INDESIT company

Model type:
AVXXL149/1EX

Commercial code:
F039135

1200110B Exploded views

n4012e01: Shallow Dispenser Kit (WMA/WD - Vogue 4)

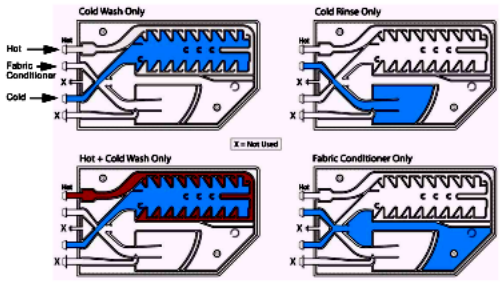
One of two types of dispenser were fitted to these models
TYPE ONE: Has separate external hose's and solenoid valve's and can be HOT & COLD or COLD fill only versions.
TYPE TWO: Has the solenoid valve's integrated into the dispenser moulding and is COLD fill only versions.
Both types will be secured to the console area by 2 screw fixings.

The Integrated type two dispenser is NO LONGER available and will need to be replaced using the Shallow dispenser kit.
NOTE: Solenoid valve's and valve supports are NOT supplied with the kit. If replacement valves are required these will need to be visually identified from images in Partfinder and ordered seperately.

The Kit will consist of the following:
•1 x Spray plate (Adapted for Universal use)
•1 x Dispenser body (2 screw hole fixing type)
•1 x Dispenser drawer (Smooth textured moulding on drawer base)
•3 x Hose's (Dispenser to valve)
•2 x Blanking Cap's (used to blank un-used water fill spigots - refer to leaflet)
•1 x Drawer latch
•3 x Cable ties

The Contents of this kit should be used to convert from a dispenser with integral valves to a dispenser with external valves / hoses.

Any unused inlet spigots on the dispenser box are to be covered with blanking caps supplied. This does not apply to the spigots which have the raised ridge, as these are already blocked.
Cold Fill Only machines will need a blanking cap fitting to the "HOT" spigot.
Ensure the correct hose is connected to the correct dispenser spigot.
Refer to the water flow diagrams to identify them.
Ensure that the hoses from the rear of the dispenser box to the valves are secured safely using Cable Ties (supplied) to avoid contact with the Top Concrete Counterweight.
